Access Compliance Report

Public Rights-of-Way

Intersection ID: 10022154	Main Street: BURNETTE_AV	Cross Street: N/A	Location: SE
ADA ID: 9FEEA24E98DD	Ramp Type: Directional1	Initial Pass/Fail: Fail	Overall Compliance: No
			Severity Score: 13.75

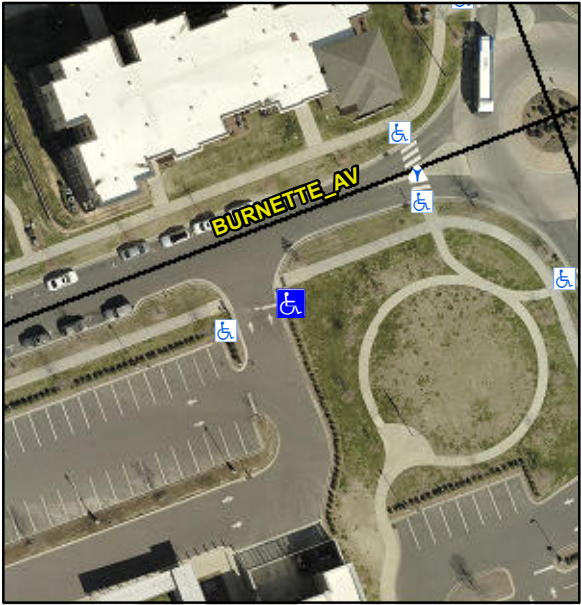
Codes/Mitigation Info/Possible Solution		Field Measurements/Component Compliance					
	Possible Solutions:	Remove & Replace Entire Ramp.					
	Surveyor Notes:	N/A					
	PROW/ADA:	R304.2.2, R304.5.3					
	Street 1 Name	ENTRANCE					
	Stop Condition-Street 1	StopSign					
	Street 2 Name	N/A					
	Stop Condition-Street 2	N/A					
			Compliance	Description	Data	Compliance	Description
			N/A	Ramp Length (in)	175.0	N/A	Grade Break?
			Yes	Ramp Width (in)	72.0	N/A	Grade Break Slope (%)
			No	Ramp Slope (%)	10.5	N/A	Grade Break XSlope (%)
			No	Ramp XSlope (%)	2.6		
			N/A	Flare Type LT	N/A	N/A	Flare Type RT
			N/A	Flare Slope LT (%)	N/A	N/A	Flare Slope RT (%)
			N/A	Flare Traversable LT?	N/A	N/A	Flare Traversable RT?
			N/A	Landing Length (in)	0.0	N/A	DWS Provided?
			N/A	Landing Width (in)	0.0	N/A	DWS Contrast?
			N/A	Landing Slope (%)	0.0	N/A	DWS Length (in)
			N/A	Landing X Slope (%)	0.0	N/A	DWS Full Width?
			N/A	Landing Curb? (Y/N)	N/A	N/A	DWS Offset LT (in)
